Re: St Peters Terminal - additional atmospheric dispersion modelling - 1.75 Mtpa handling facility throughput - response to EPA letter

The NSW Department of Planning, Industry and Environment (DPIE) received technical review comments for the Modification 12 air quality impact assessment (MOD12 AQIA) from the NSW Environment Protection Agency (EPA) in a letter dated 24 July 2020 (the EPA letter). The recommendations from the EPA and associated responses are presented in the following sections.

Figure 2.1 Contribution to predicted additional cumulative 24-hour average PM_{2.5} concentration exceedance— receptor R4

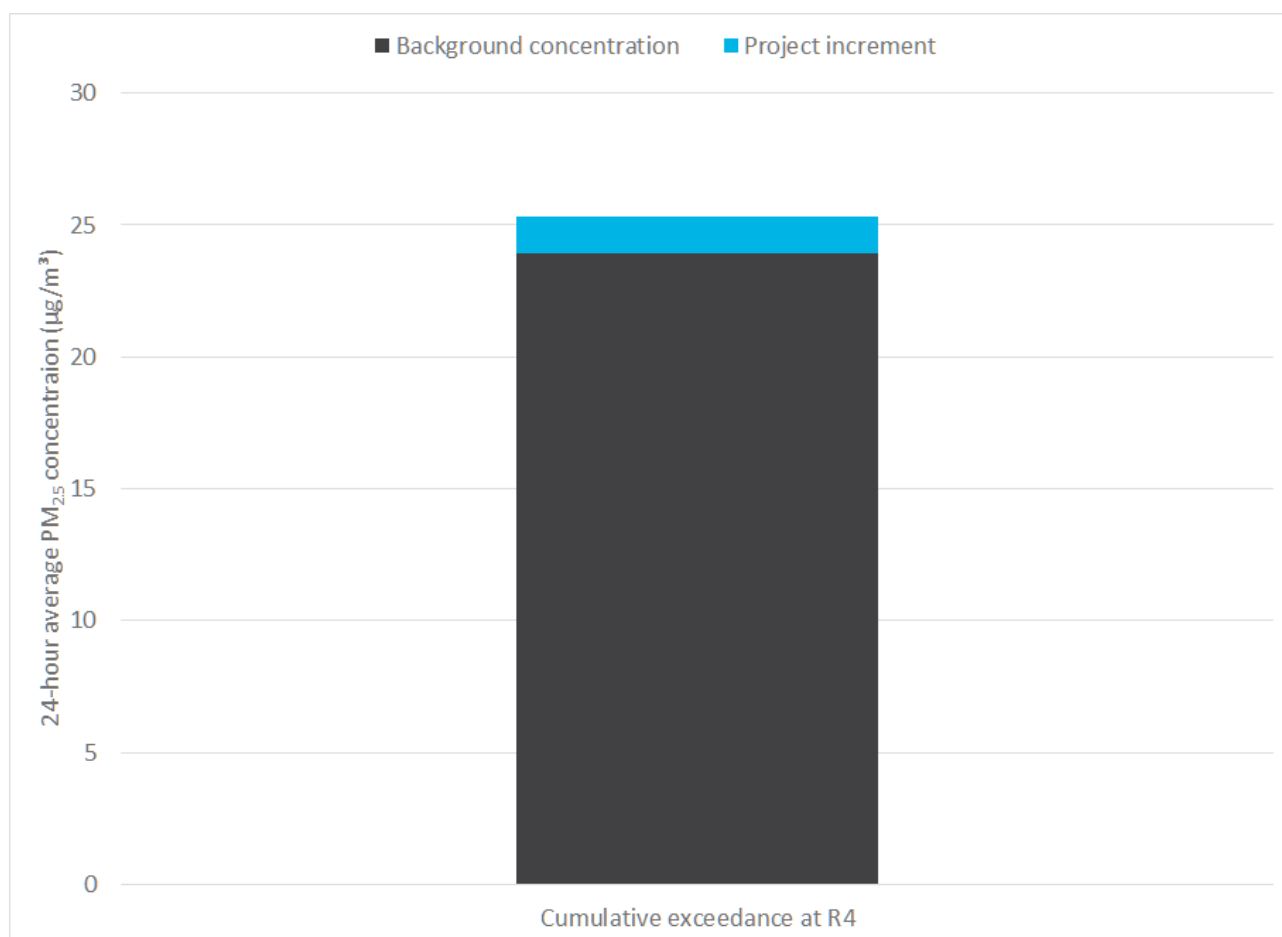
The additional AQIA does not clarify whether a contemporaneous assessment of particulate impacts was undertaken or whether the highest predicted incremental concentrations were added to the highest (non-exceedance) background concentration (2015 Earlwood).

On page 2 of the letter, the EPA has presented cumulative impact assessment calculations for receptor R3 (cumulative 24-hour average PM₁₀) and R4 (cumulative 24-hour average PM₁₀). The Earlwood 2015 PM₁₀ and PM_{2.5} monitoring datasets were used as background consistent with the MOD12 AQIA. There are one and two recorded concentrations above the applicable EPA impact assessment criteria for PM₁₀ and PM_{2.5} respectively in the Earlwood 2015 dataset.

Similarly, to assess cumulative 24-hour average PM_{2.5} concentrations, the EPA has combined the maximum predicted site only incremental 24-hour average PM_{2.5} concentration at R4 with all daily varying PM_{2.5} concentrations from the 2015 Earlwood PM_{2.5} monitoring dataset. The EPA calculated three additional exceedances of criteria for 24-hour average PM₁₀ at receptor R4.

Nevertheless, EMM can confirm that the MOD12 AQIA undertook a contemporaneous cumulative assessment approach, consistent with the Level 2 assessment approach detailed in Section 5.1 of the Approved Methods for Modelling (EPA 2016). As stated in the MOD12 AQIA, a single additional exceedance day was predicted at receptor R4 for 24-hour average PM_{2.5}. This exceedance coincided with a background concentration of 23.9 µg/m³. The contribution to the cumulative exceedance at R4 is illustrated in Figure 2.1.

It can be seen from Figure 2.1 that the background concentration dominates the cumulative concentration (approximately 94%). The other following points are noted:

- the modelling results relate to peak day activity rates occurring continuously throughout the modelling period, which is a highly conservative assumption;
- by adopting the maximum annual throughput at the handling facility, the modelled scenario relates to the worst-case potential for operational split with regards to air emissions and impacts.
- the impacted receptor in question is an industrial receptor that would not be exposed to an entire 24-hour averaging period.
